# SAFETY RECALL BULLETIN

## NHTSA RECALL 20V013

AUTOCAR, LLC SAFETY RECALL ACX-2001

Autocar has determined that a safety concern exists with the ignition relay.

**Figure 4**

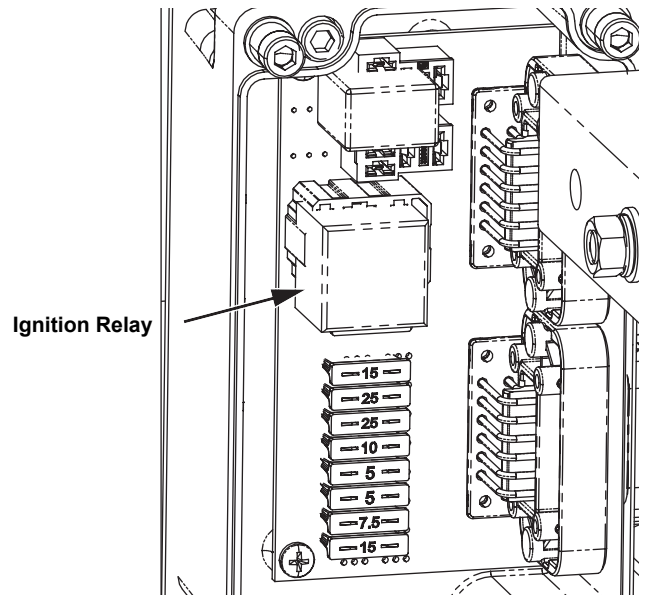
5. Remove the ignition relay and discard (see Figure 4).

6. Install the GZ130026-001 relay.
7. Using rubbing alcohol, clean the inside of fuse box cover set aside in Step 4.
8. Remove the protective backing to expose the adhesive and install the A8701012-001 fuse holder insert in upper right corner of the fuse box cover with the tallest rib towards the cover key (see Figure 5).

**Figure 5, Inside Fuse Box Cover**

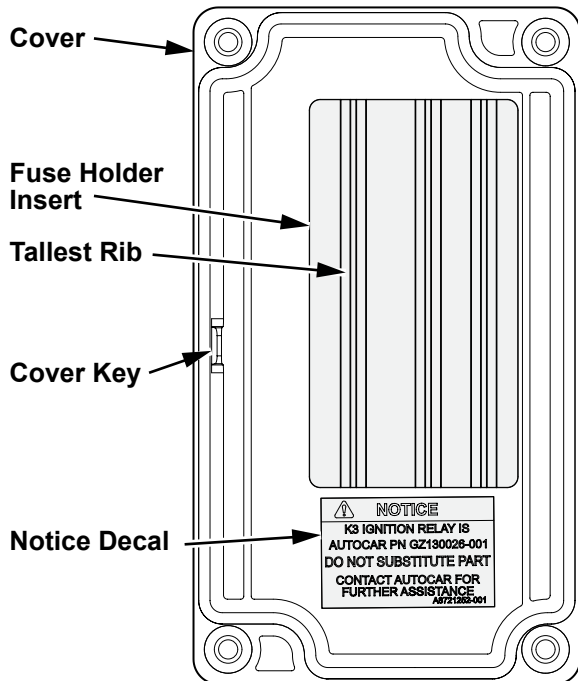
9. Remove the protective backing to expose the adhesive and install the A8721252-001 notice decal below the fuse holder insert (see Figure 5).

10. Reinstall fuse box cover and tighten the screws to 16 lb-in of torque.
11. Reconnect the batteries.
12. Lower the cab.
13. Start the engine and check all electrical functions.
14. Installation is complete.
